RESPONSES TO NRC QUESTIONS ON  
THE ROCS-DIT TOPICAL

CENPD-266

AMENDMENT 1-NP

February 1983

FIGURE 4-2

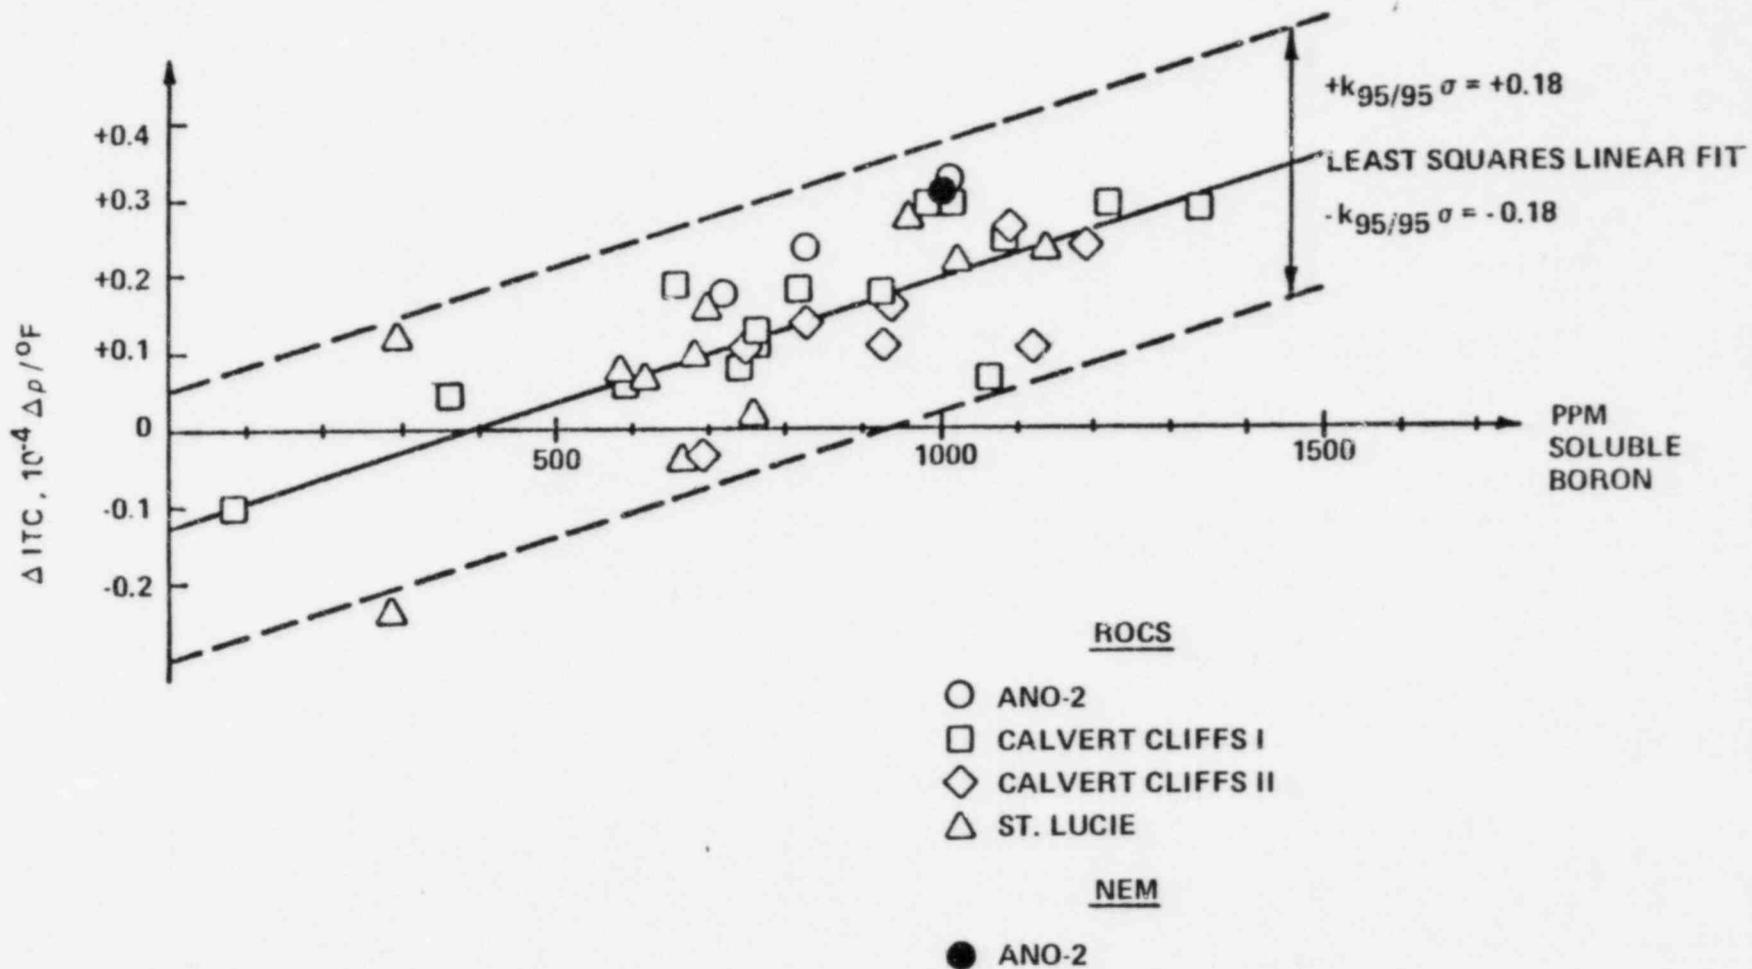
Replace Figure 4.2 by the attached Figure 4.2 and add a new Table 2.2 and renumber the current one as Table 2.3.

"Comparisons of rod worths, critical ppm and ITC for the 3-D ANO-2 model obtained using HERMITE (NEM) and ROCS (HOD) are given in Table 2.2. The critical ppm are essentially identical. The comparison also shows good agreement in bank worths with a maximum difference of [ ] between NEM and HOD. The bank worths with NEM give comparable agreement to measured values as seen by comparing the values with those in Table 4.18. The ITC agreement between NEM and HOD is also good. The comparison with measurement is given in Figure 4.2."
